**DATE:** June 25, 2014  
**SUBJECT:** Letter of Clarification No. 2  
**REFERENCE:** Wortham Building Automation System Upgrade  
**TO:** All Prospective Proposers:

# GRBCC BAS System Typical Interface Screens

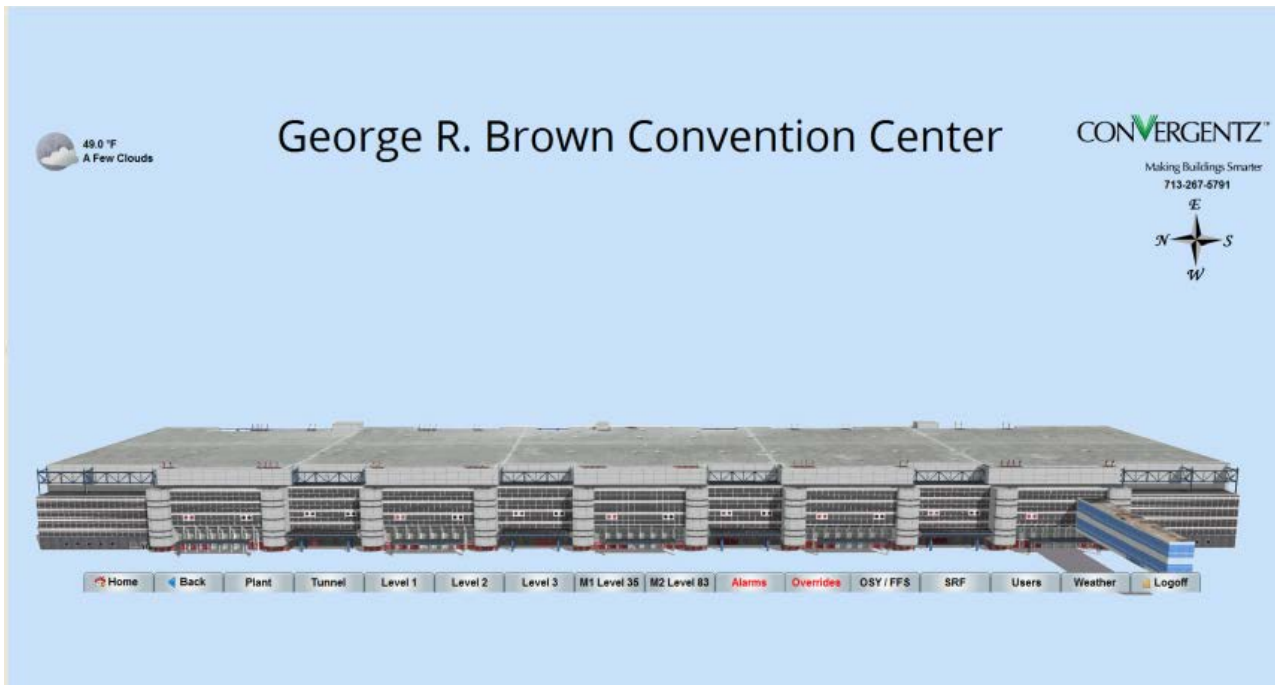
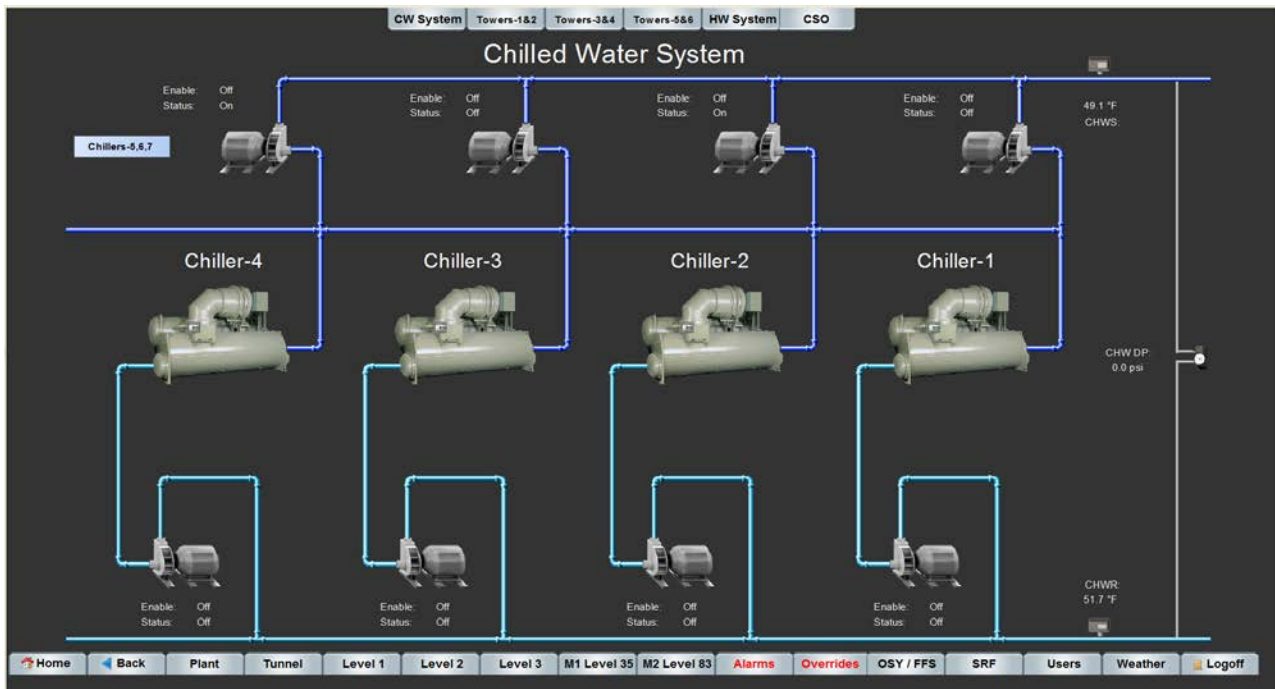
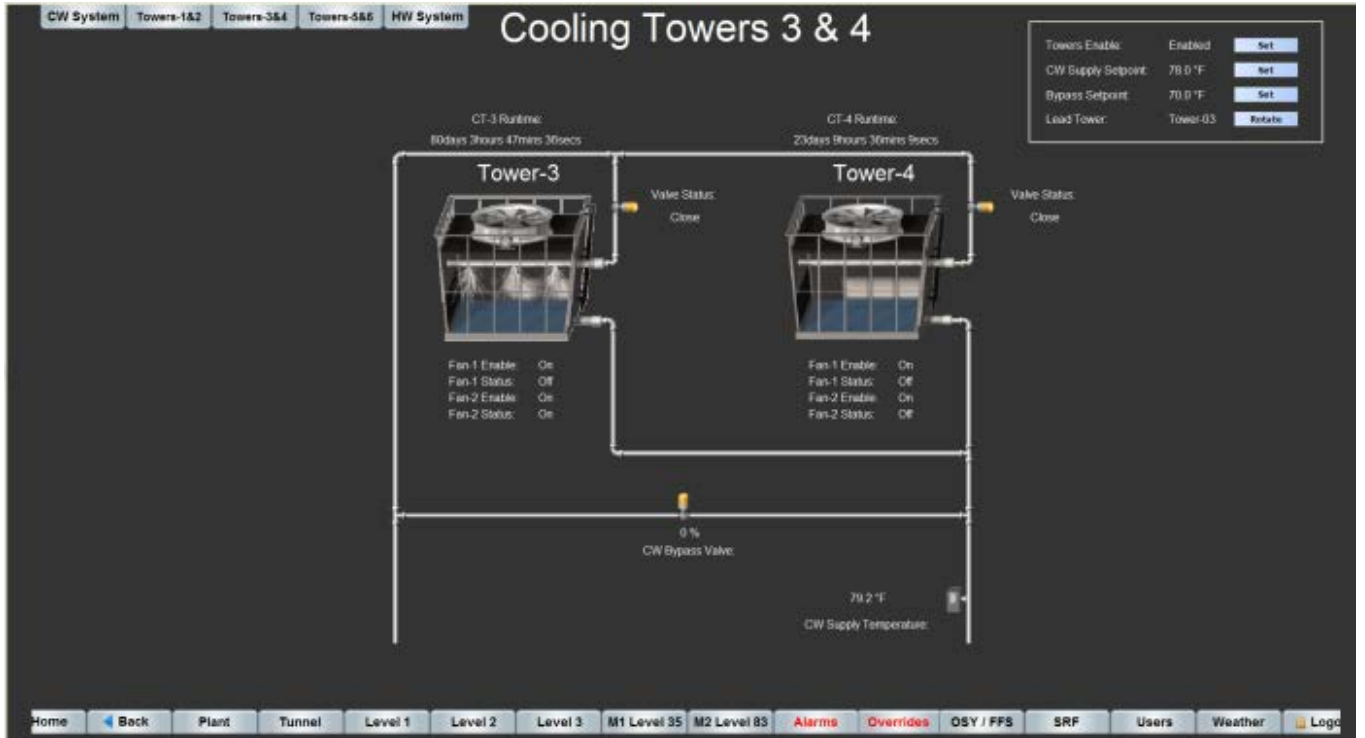
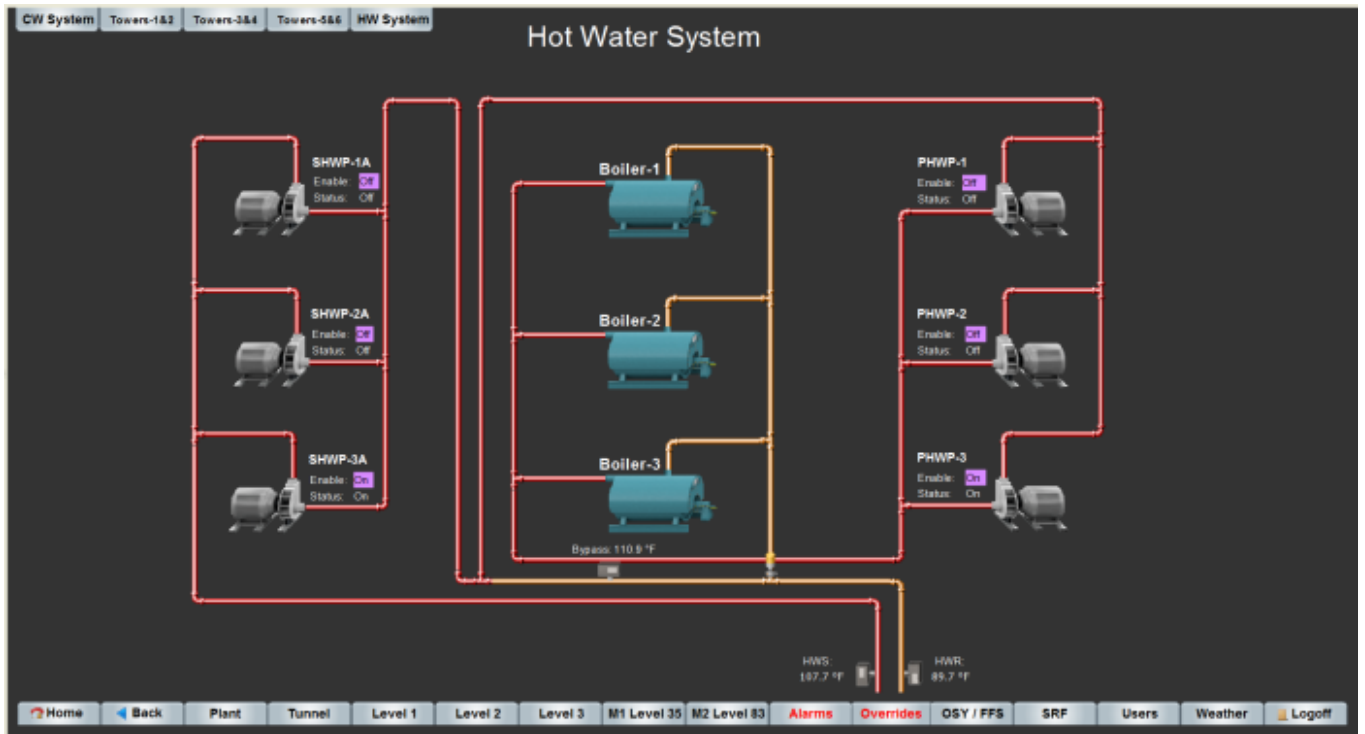
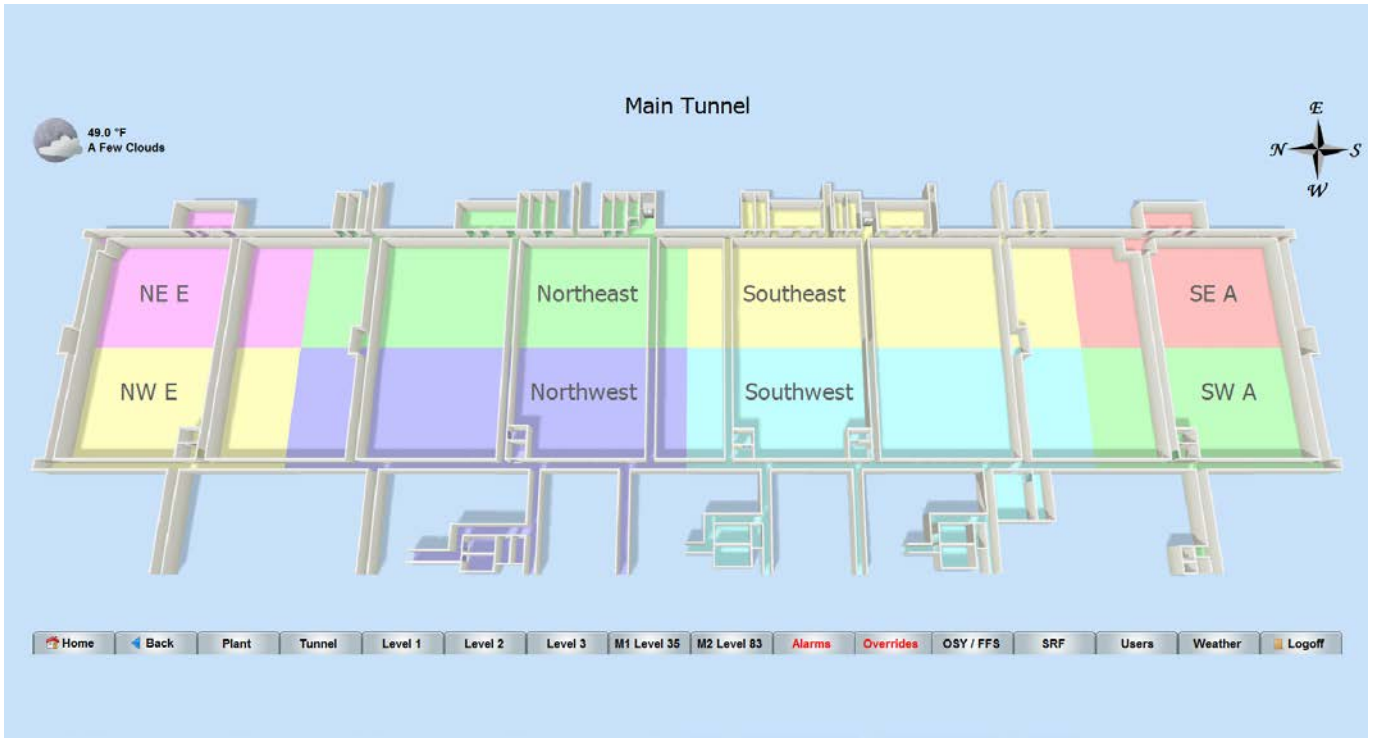
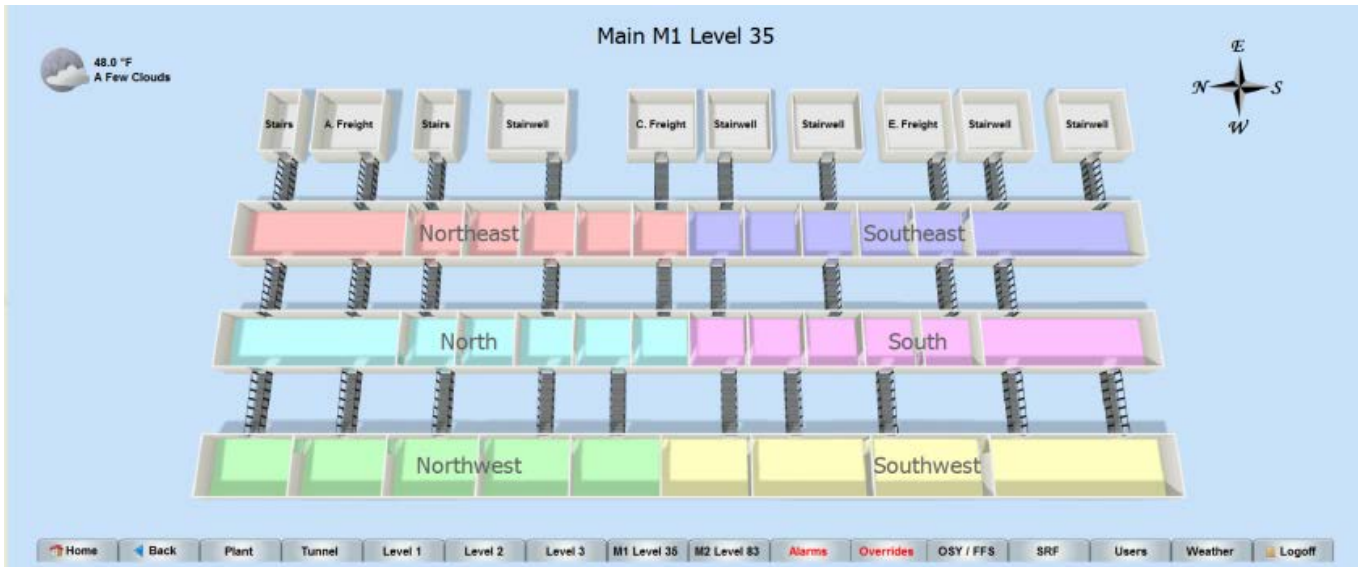
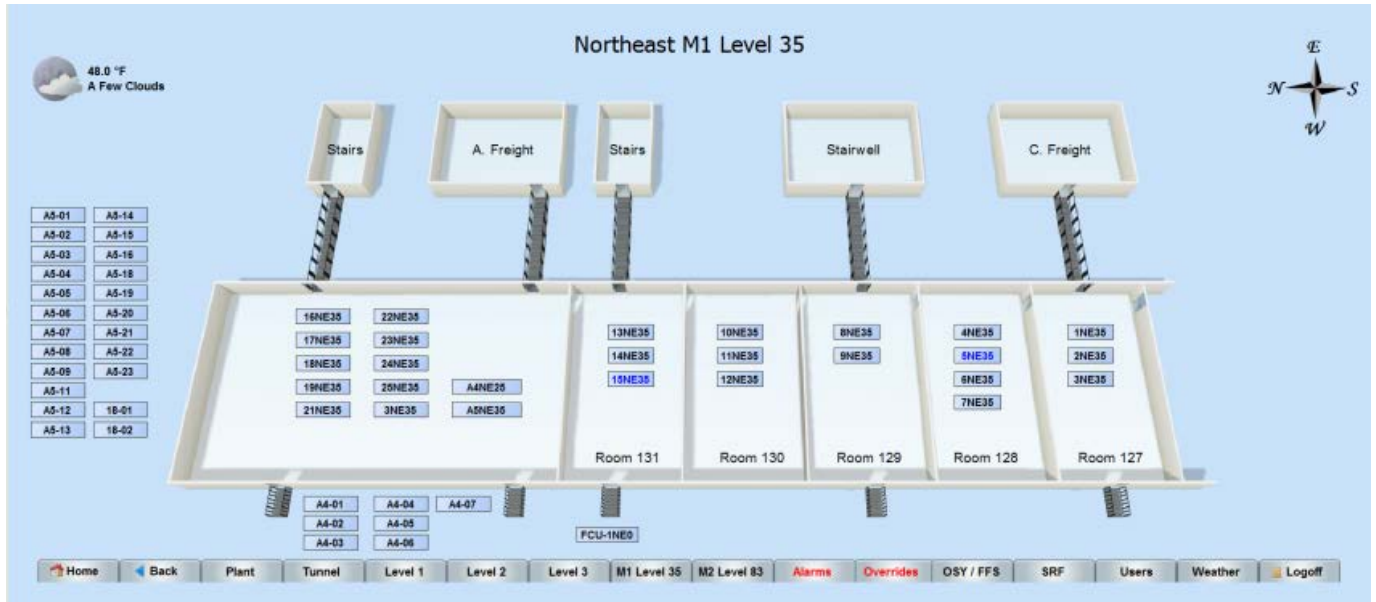
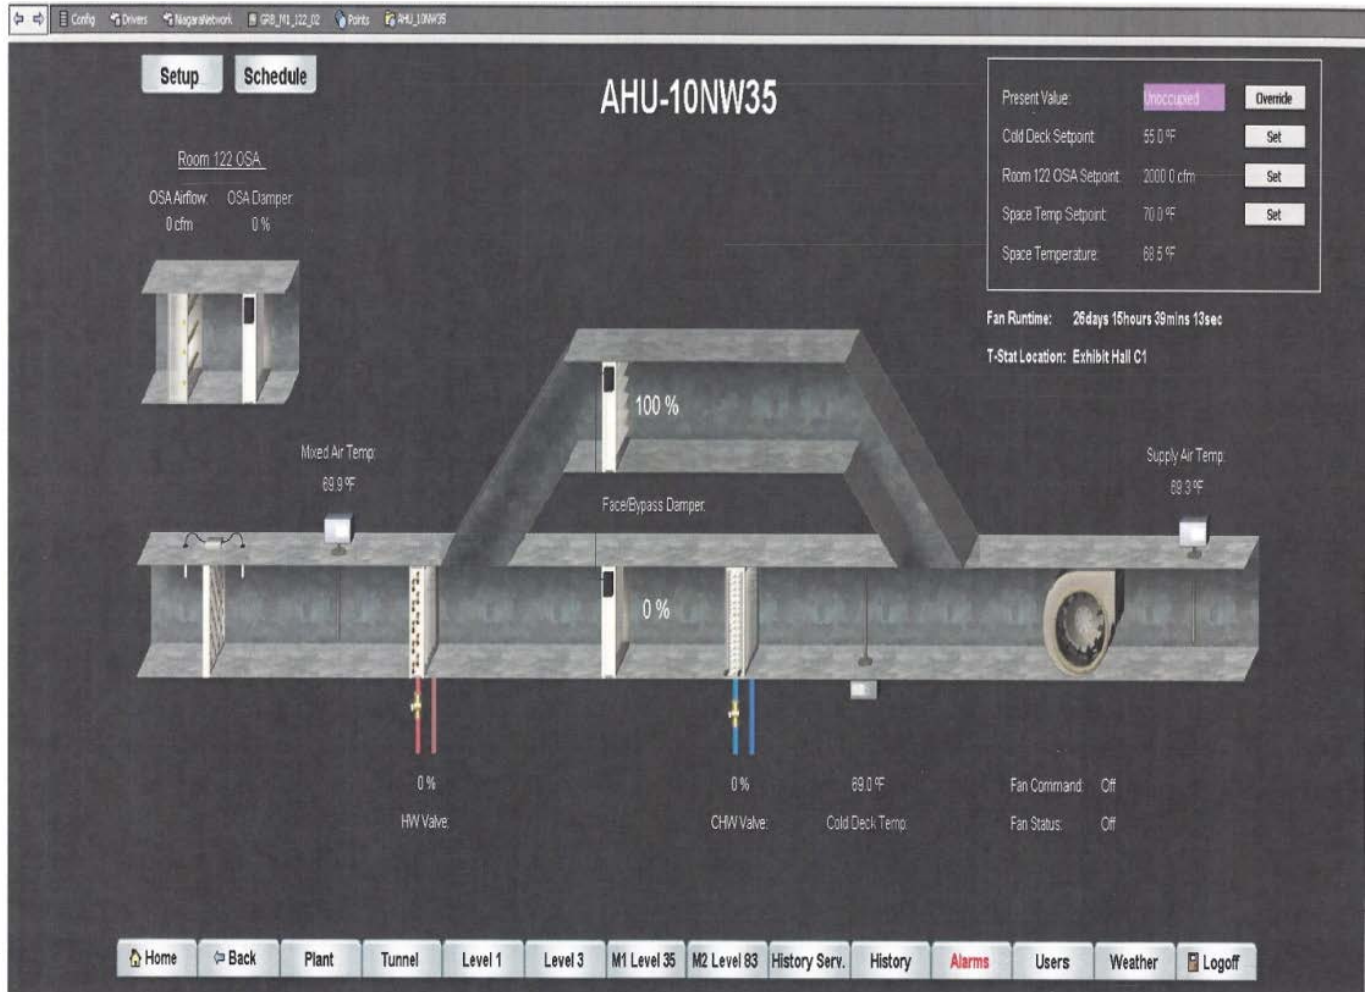
1. **Question:** Can you please provide examples of the graphics for the system located at George R. Brown?

**Answer:** Attached "Typical Screens for Bas System-GRBCC" are sample screen shots from the GRBCC BAS systems ( see requirement in spec section 23 09 23- 1.2-B-7)
